CALIFORNIA COASTAL COMMISSION

DATE: July 21, 2005

RE: **Notice of Impending Development 2-05 (East Bluff Fence)**, Pursuant to the University of California Santa Barbara Certified Long Range Development Plan (LRDP) for Public Hearing and Commission Action at the meeting of August 10, 2005 in Costa Mesa.

EXHIBIT 2
UCSB NOID 2-05
Site Plan

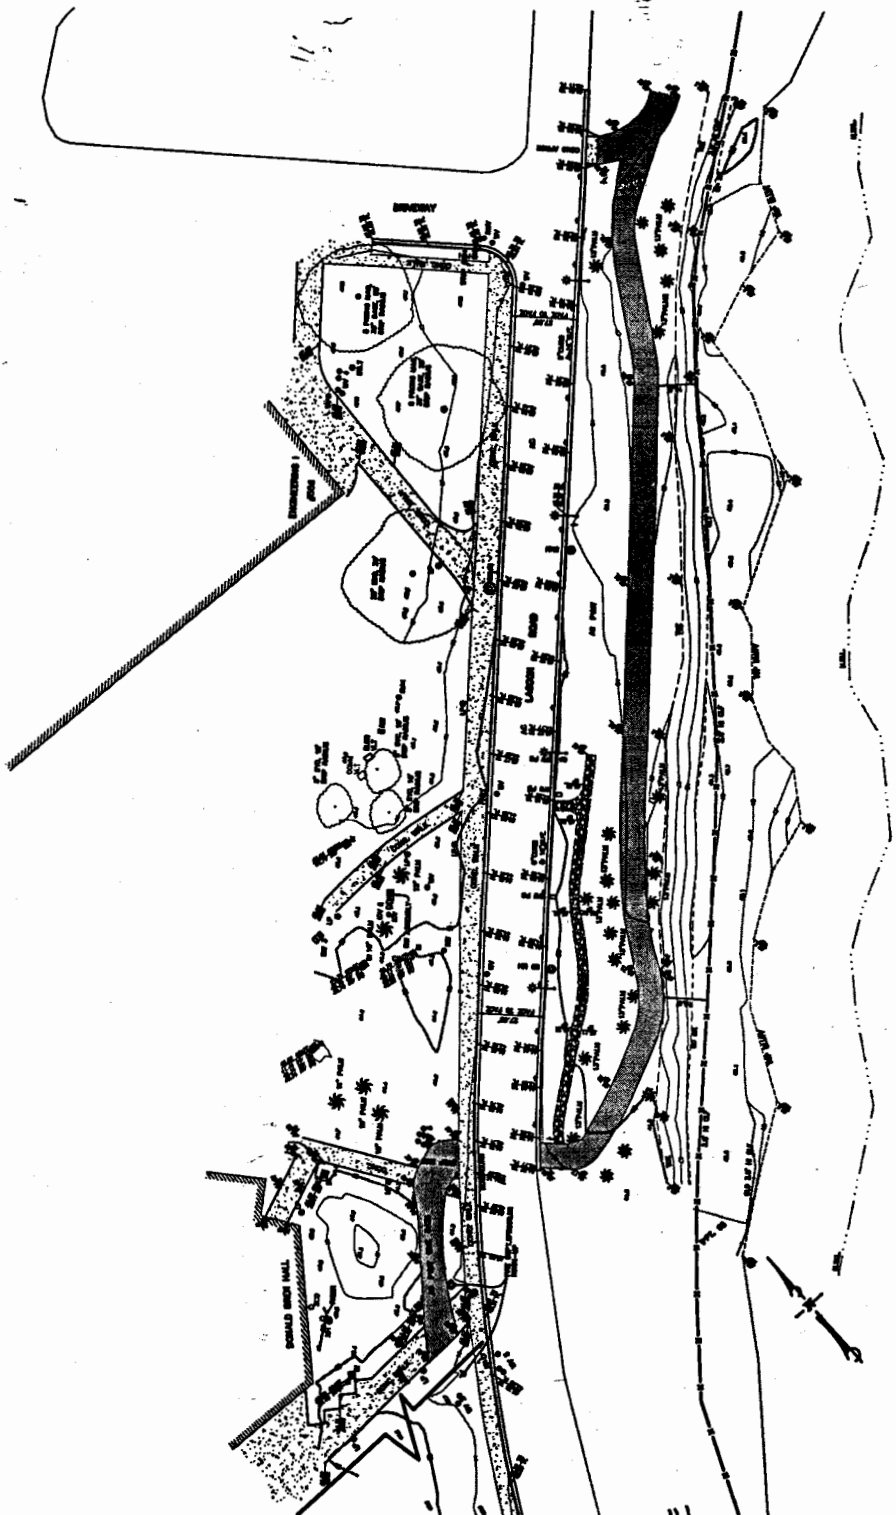
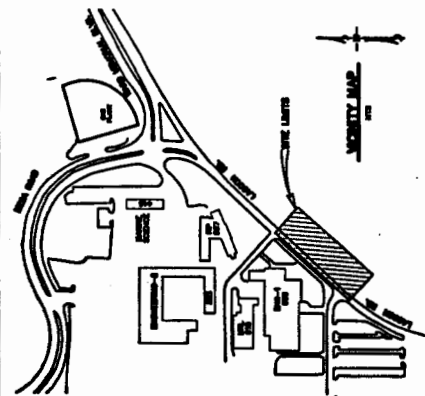
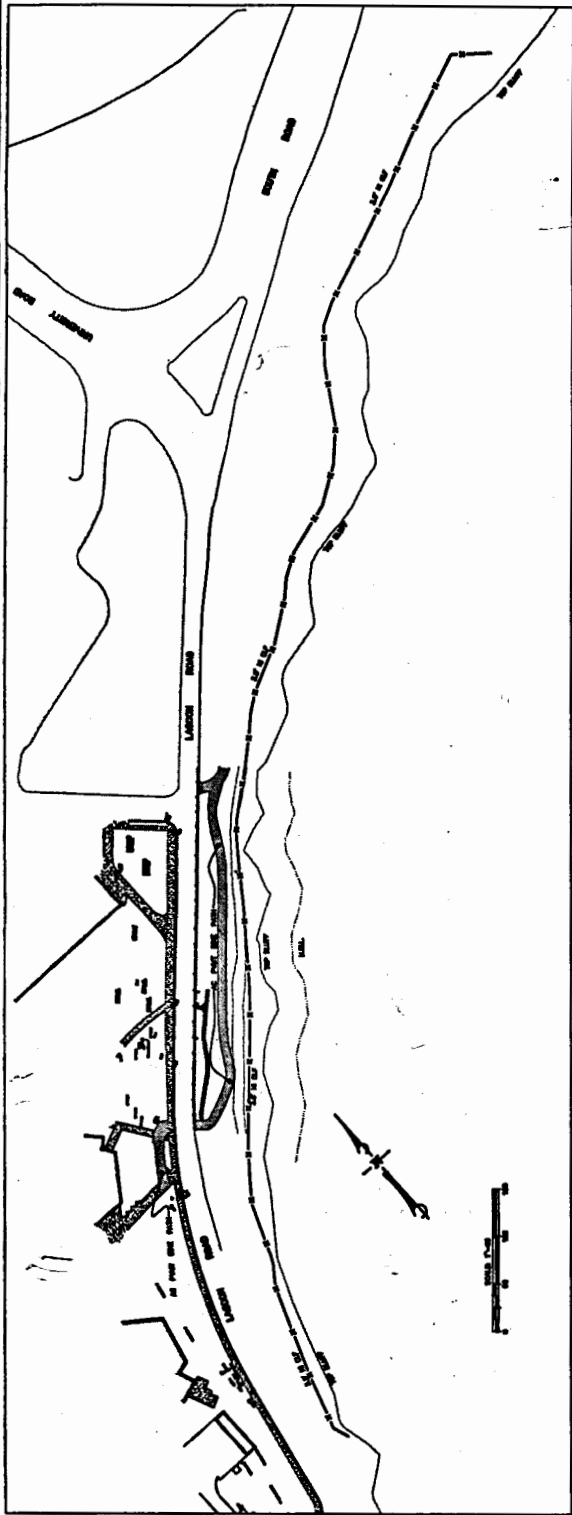
The impending development consists of an as-built 2,000 linear foot, 3½ ft. high chainlink fence along the top of the east campus bluff on the Main Campus (Exhibit 2). The fencing roughly parallels the bluff top and a number of pedestrian and bicycle trails used by the public as coastal access routes. Additionally the fence is visible from primary coastal vantage points on campus, such as Lagoon Road and public viewing locations off campus including the Santa Barbara County Park at Goleta Beach. As proposed, the fence is a maximum of 3½ feet in height. This low profile is consistent

with the visual resource policies and provisions of the LRDP. However, the Commission finds that the chainlink design of the east bluff fencing does not protect views to and along the coast and is not compatible with visual character of the surrounding area. The Commission notes that the placement of fences along bluff top property is generally discouraged in order to minimize adverse impacts to coastal views, both from the beach of the bluff and from any bluff top viewing areas. However, in this case, the University has asserted that the fence is necessary to ensure public safety on campus. Therefore, in order to provide for the provision of public safety while also minimizing adverse impacts to visual resources as required by Coastal Act Section 30251, as incorporated into the certified LRDP, the Commission requires the University to submit revised plans for a fence using an alternative design that will minimize adverse impacts to views from the publicly used trails and coastal access routes to the adjacent coastal areas, pursuant to Special Condition One (1). Appropriate modified fence design(s) shall be more visually permeable and shall maintain the extensive and generally unimpeded visual character of the area, which may include a post and cable fence, split-rail fence, or other visually open design. Special Condition 1 requires that the University submit, for the review and approval of the Executive Director, two (2) sets of final revised fence plans within 60 days of Commission action on NOID 2-05. Alternative designs may be allowed if the Executive Director determines that such designs are consistent with the intent of this condition and serve to minimize adverse effects to public views.

This NOID includes the after-the-fact request for a determination that the installation of fencing along the bluff is consistent with the LRDP. As explained above, a chainlink fence is not consistent with the LRDP, and therefore Special Condition One (1) requires the University to submit revised project plans that modify the fencing type so it will minimize adverse impacts to scenic views.

- A. Within 60 days of Commission action on NOID 2-05, the University shall submit, for the review and approval of the Executive Director, two (2) sets of final revised project plans. The revised final project plans and project description shall reflect the following:
1. The fence shall be a post and cable fence, a split rail fence, or other similar, visually open design consistent with the provision of public safety subject to the review and approval of the Executive Director. Alternative designs may be allowed if the Executive Director determines that such designs are consistent with the intent of this condition and serve to minimize adverse effects to public views.
- B. The fence shall be constructed in compliance with the revised project plans approved by the Executive Director.
